Statement of Compliance Access For People With A Disability

Macquarie Village
110-113 Herring Rd Macquarie Park

Accessible Building Solutions
124 Upper Washington Drive
Bonnet Bay NSW 2226

Section 1: Concept Plan

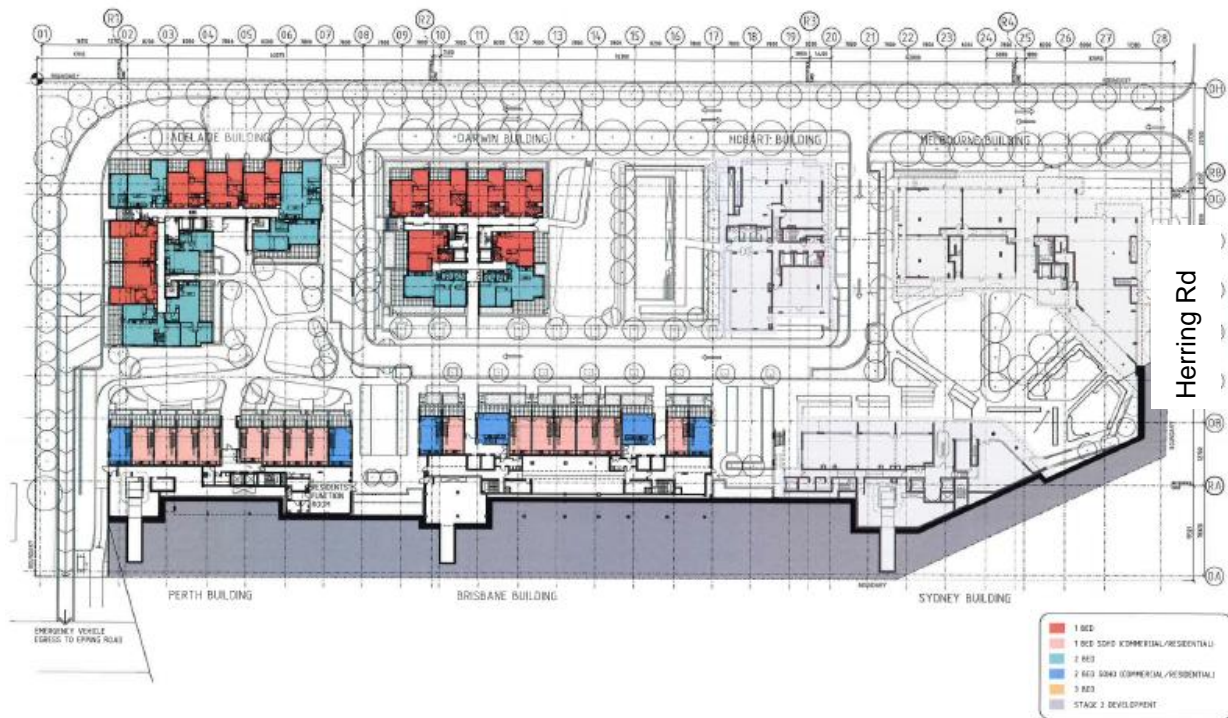
For people with disabilities, the proposal provides:

- Footpaths providing an accessible path to each building from the street
- On street and basement carparking
- Kerb ramps to AS 1428.1 to provide access from the road to the footpath level
- Access to all levels of each building by way of a lift complying with BCA 2013.
- Access to communal facilities.

I am satisfied that the proposal will provide appropriate access for people with disabilities throughout the development.

Section 2: Stage 1 Proposal

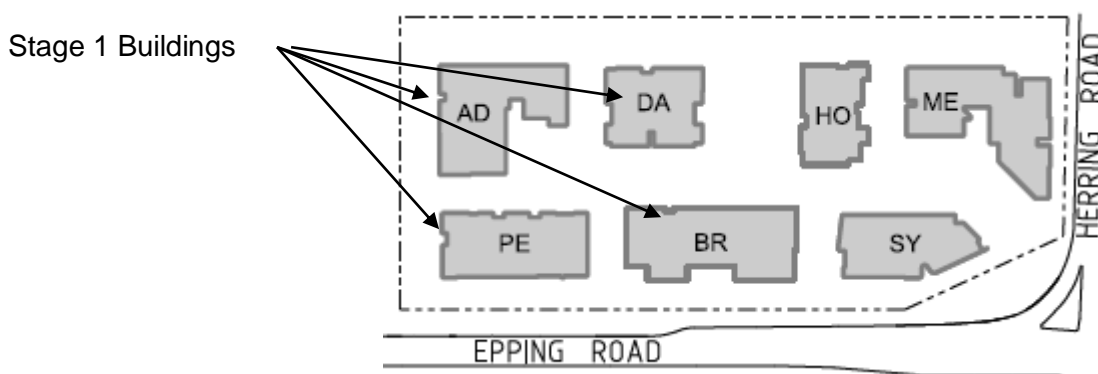
Each building has been assessed separately, and for the sake of brevity, these assessments have been incorporated into the following table.

Based on the preceding assessment, I am satisfied that the proposal will comply with the access provisions of the BCA 2013 and that a minimum of 10% of the units will comply with AS 4299 as adaptable.
